TSG-RAN Meeting #16
Marco Island, FL, USA, 4 - 7 June 2002

RP-020335

Title: Agreed CRs (Release '99 and Rel-4/Rel-5 category A) to TS 25.331 (6)

Source: TSG-RAN WG2

Figure 14.4.2.1-1: Event triggered report when Transport Channel Traffic Volume ~~exceeds~~becomes larger than a certain threshold

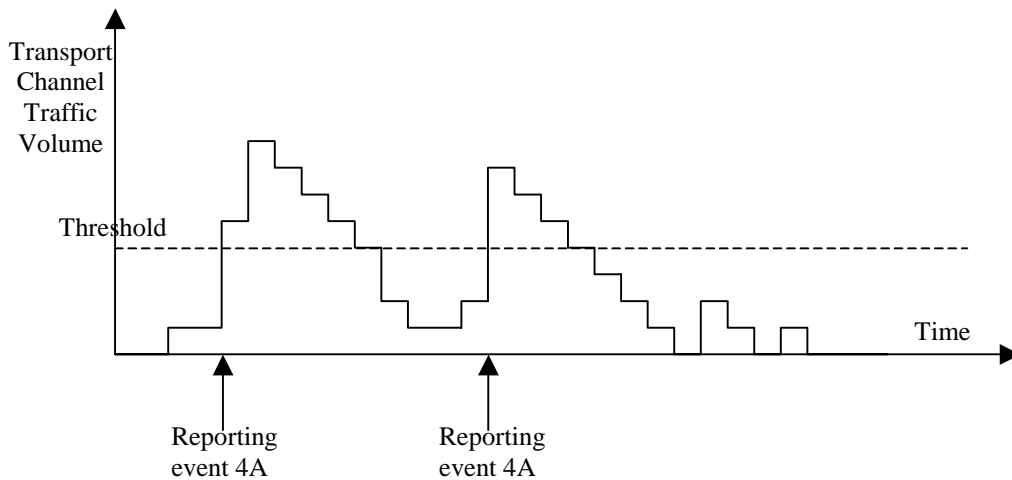
14.4.2.1 Reporting event 4 A: Transport Channel Traffic Volume ~~exceeds~~becomes larger than an absolute threshold

If the monitored Transport Channel Traffic Volume [15] ~~exceeds~~becomes larger than an absolute threshold, i.e. if $TCTVF > \text{Reporting threshold}$, this is an event that could trigger a report. ~~The corresponding report specifies at least which measurement ID the event that triggered the report belongs to.~~

Figure 14.4.2.1-1: Event triggered report when Transport Channel Traffic Volume ~~exceeds~~ becomes larger than a certain threshold

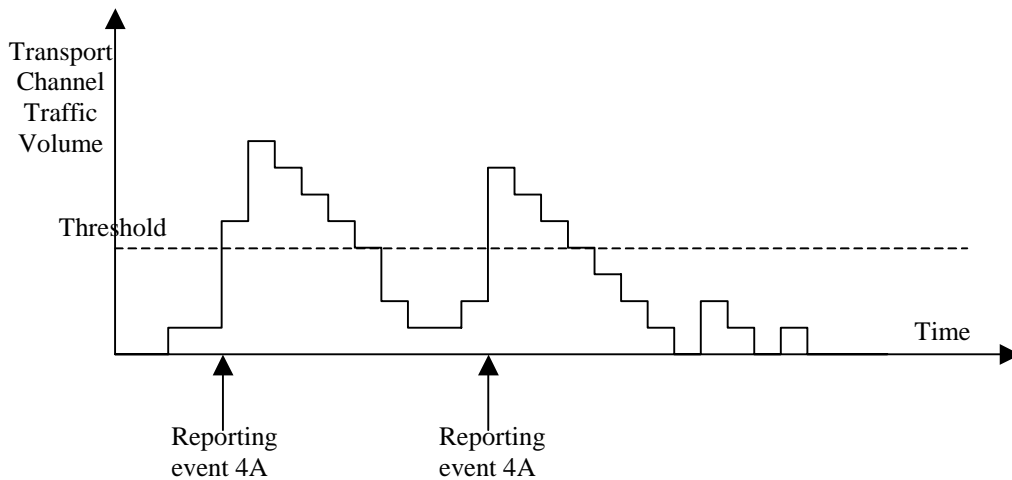
14.4.2.1 Reporting event 4 A: Transport Channel Traffic Volume ~~exceeds~~ becomes larger than an absolute threshold

If the monitored Transport Channel Traffic Volume [15] ~~exceeds~~ becomes larger than an absolute threshold, i.e. if $TCTVF > \text{Reporting threshold}$, this is an event that could trigger a report. The corresponding report specifies at least which measurement ID the event that triggered the report belongs to.

Figure 14.4.2.1-1: Event triggered report when Transport Channel Traffic Volume ~~exceeds~~ becomes larger than a certain threshold

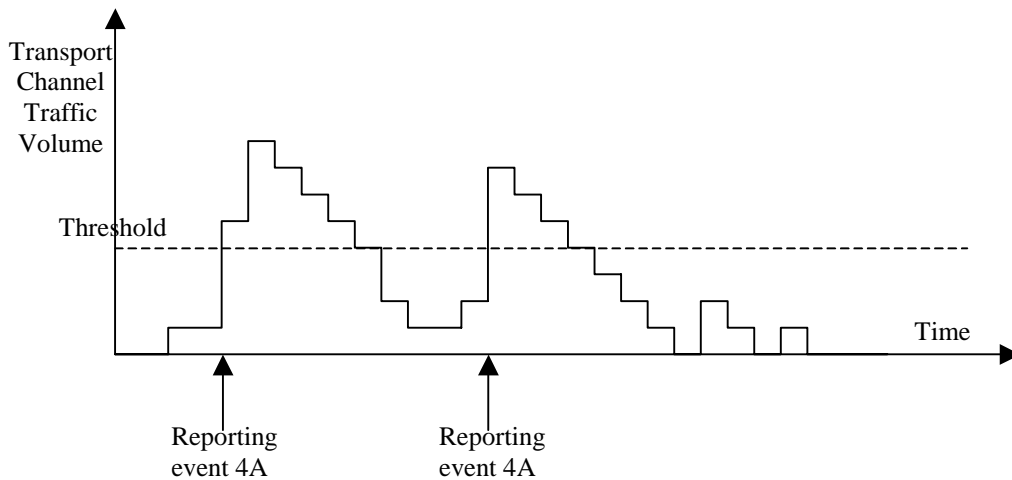
14.4.2.1 Reporting event 4 A: Transport Channel Traffic Volume ~~exceeds~~ becomes larger than an absolute threshold

If the monitored Transport Channel Traffic Volume [15] ~~exceeds~~ becomes larger than an absolute threshold, i.e. if $TCTVF > \text{Reporting threshold}$, this is an event that could trigger a report. The corresponding report specifies at least which measurement ID the event that triggered the report belongs to.
